OB-Xa
PROGRAMMABLE POLYPHONIC SYNTHESIZER

THIRD EDITION JUNE 1982

ENGINEERING CHANGE ORDERS (ECOs)

UPPER CONTROL BO:
1517A SHEET 2

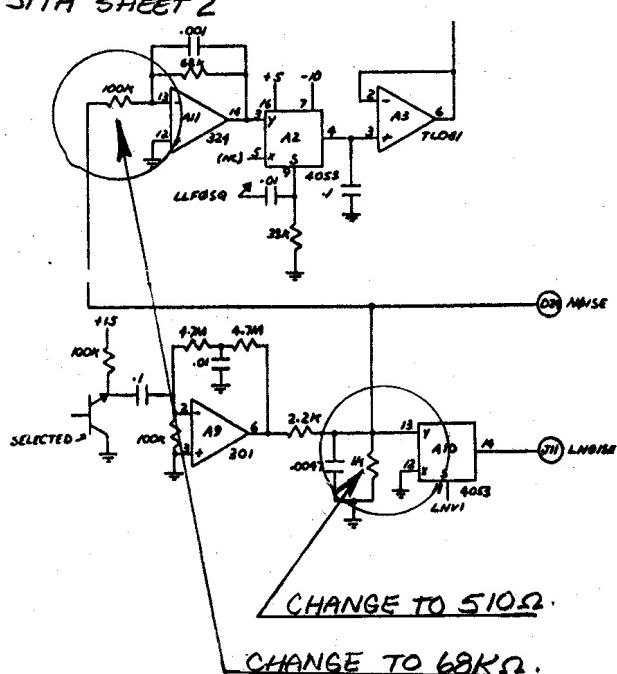
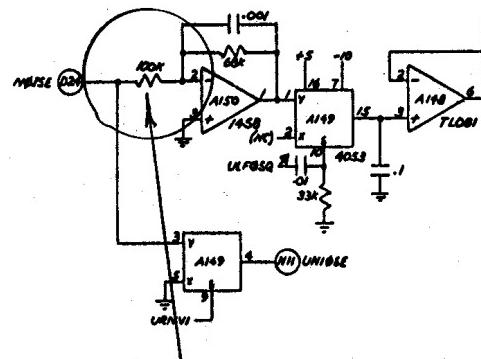
- CHANGE 3 RESISTORS

CHANGE TO 68KΩ.

SCHEMATIC 1517A SHEET 2 UPPER CONTROL

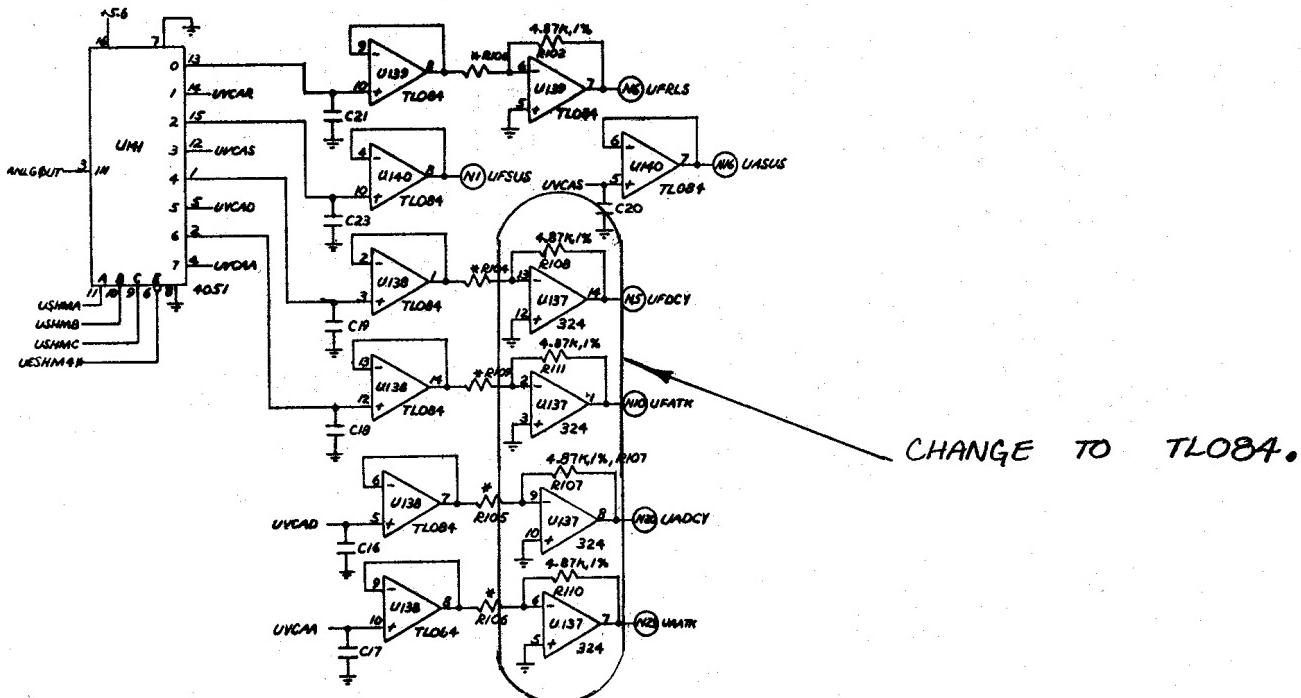
CHANGE U137 FROM AN LM324 TO A TL084.

136

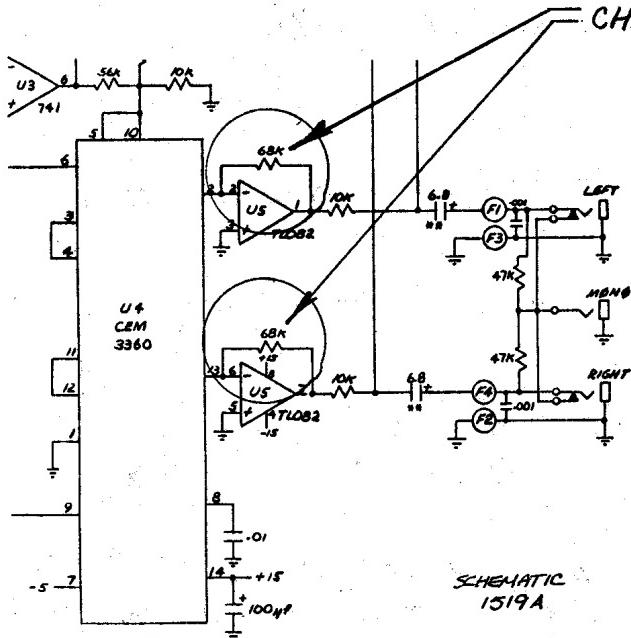
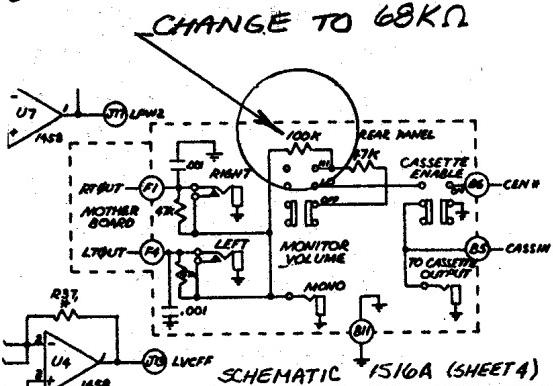
- CHANGE A TOTAL OF 4 RESISTORS PER OB-XA UNIT FROM 68K TO 120K.

CHANGE TO 120K ON TWO MOTHER BOARDS.

- CHANGE RESISTOR ON CASSETTE MONITOR SWITCH (REAR PANEL) TO 68KΩ. THIS RAISES CASSETTE MONITOR VOLUME, KEEPING RATIO OF THE VOLUMES OF SYNTHESIZER OUTPUT AND CASSETTE MONITOR CONSISTANT.

143

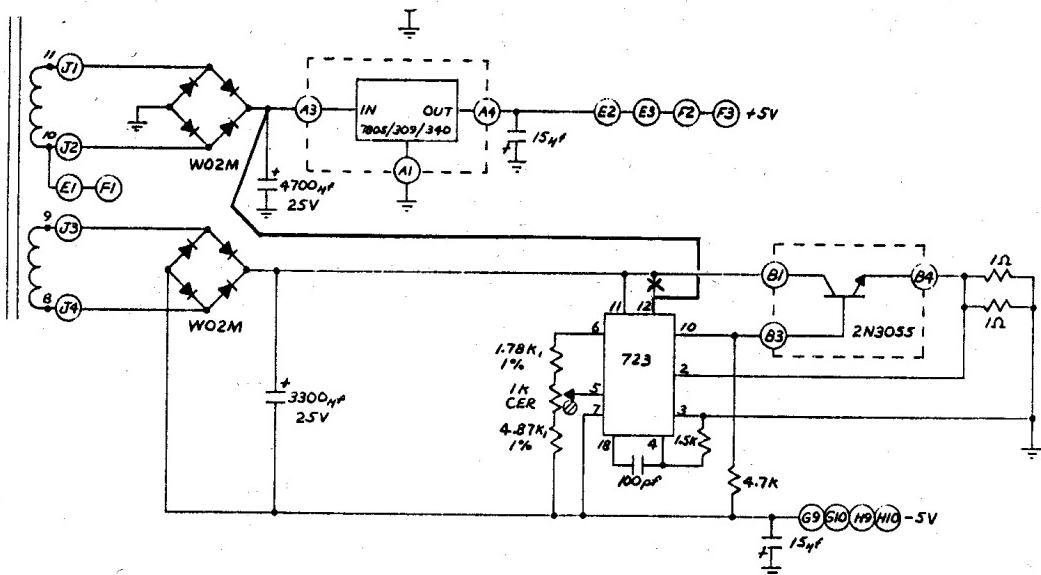
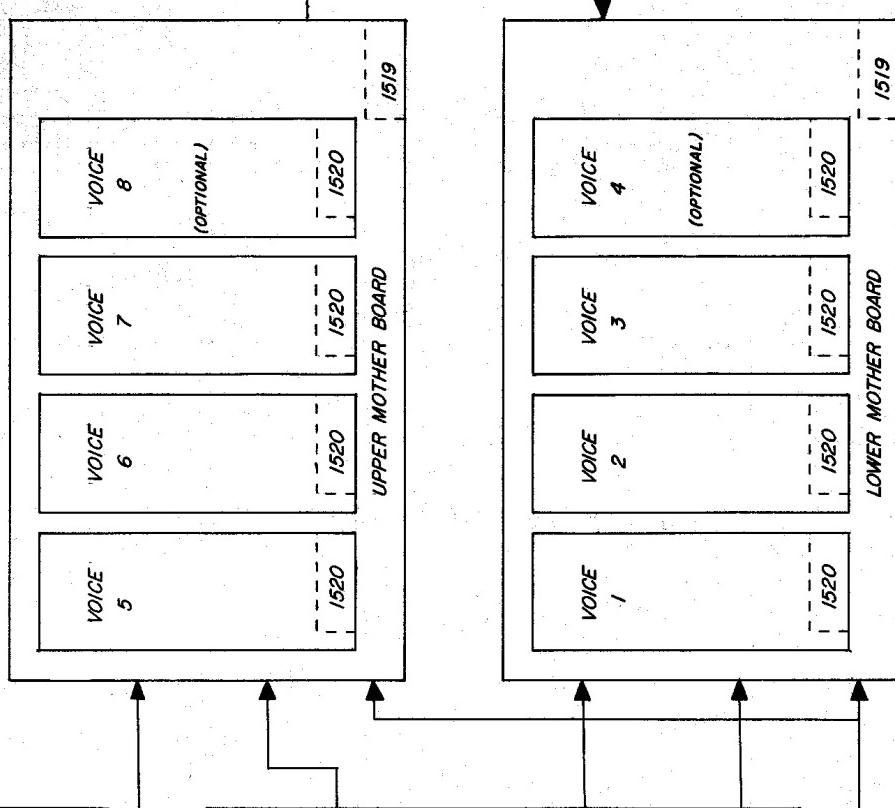
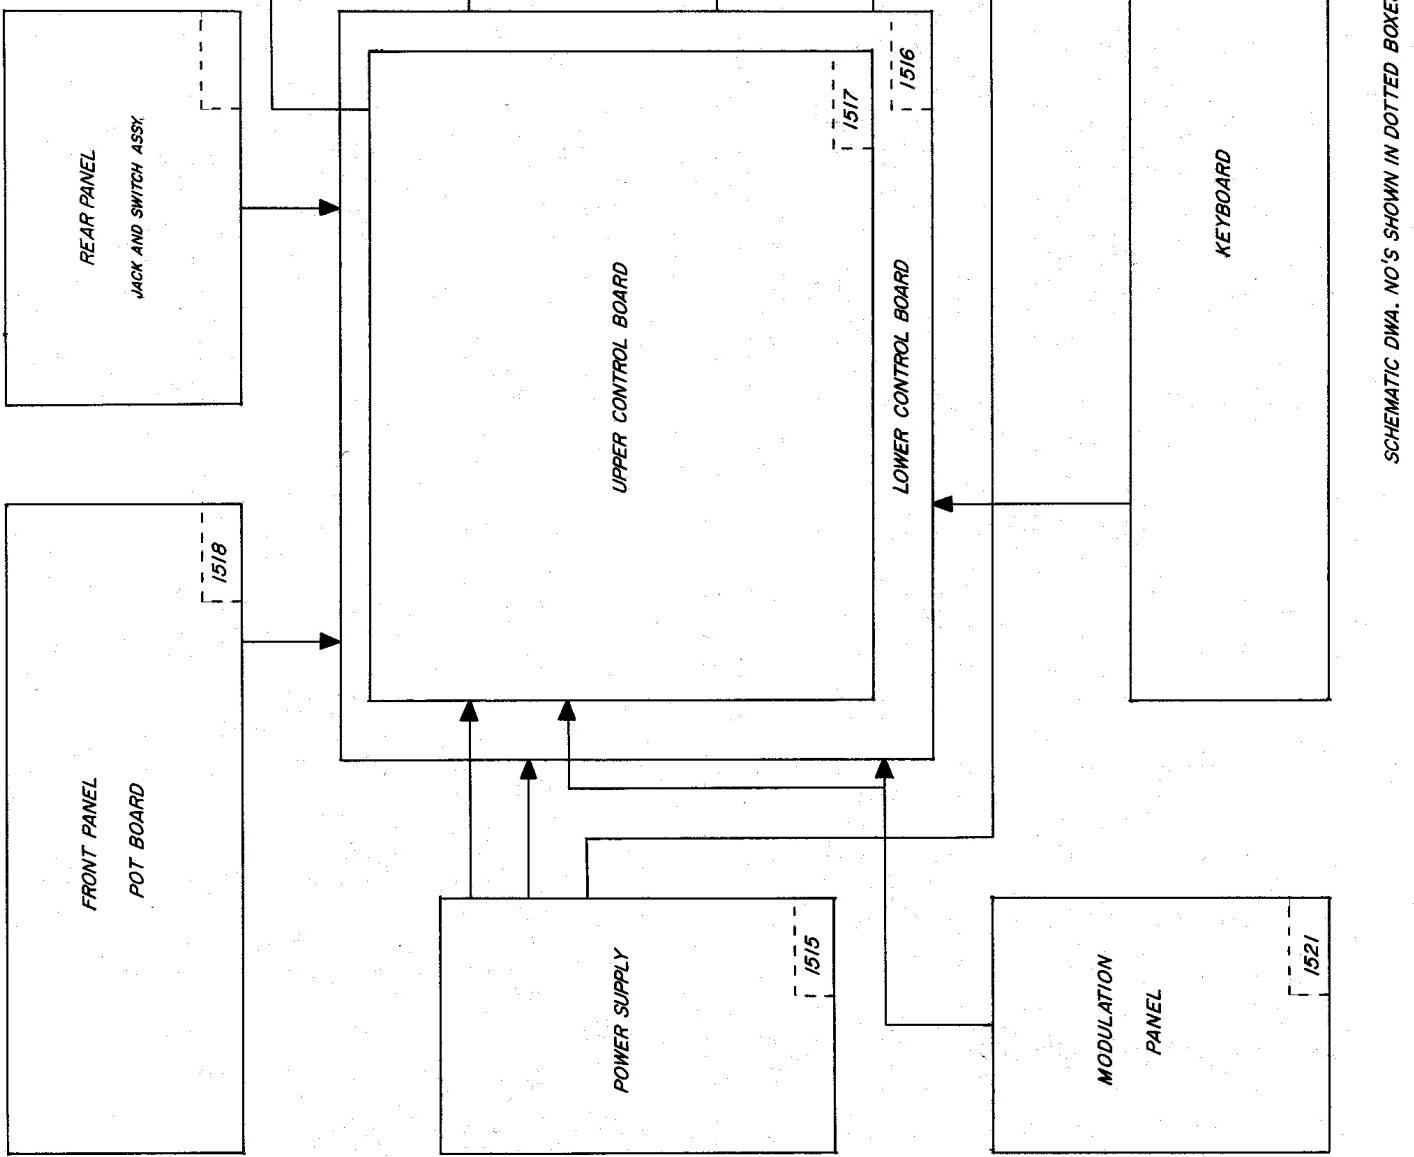
Allow for operation down to 90 VAC input.
